Economic Commission for Europe**Inland Transport Committee****World Forum for Harmonization of Vehicle Regulations****Working Party on Brakes and Running Gear****Eighty-second session**

Regulation No. 55**Proposal for amendments to Regulation No. 55 (Mechanical couplings)****Submitted by the Chair of the informal working group on Regulation No. 55***

Figure 17, amend to read:

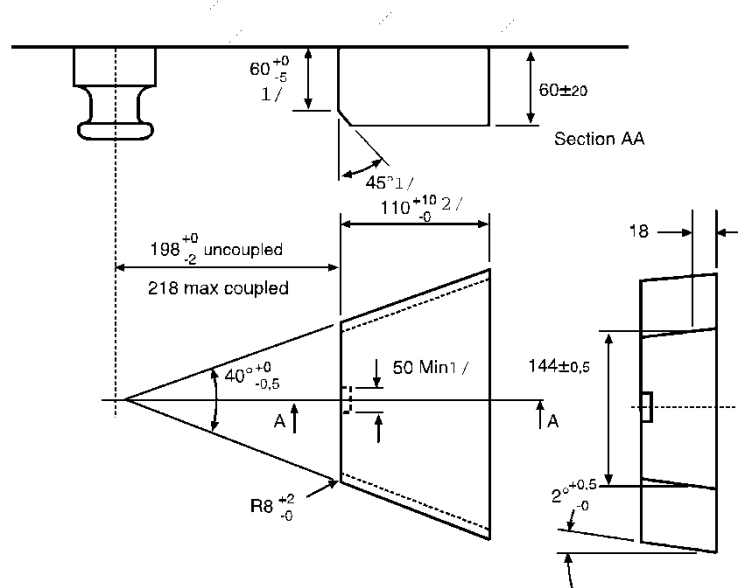
Paragraph 7.3.2., amend to read:

"7.3.2. $\pm 12^\circ$ **6° towards the front and 7° towards the rear** about the horizontal axis transverse to the direction of travel."
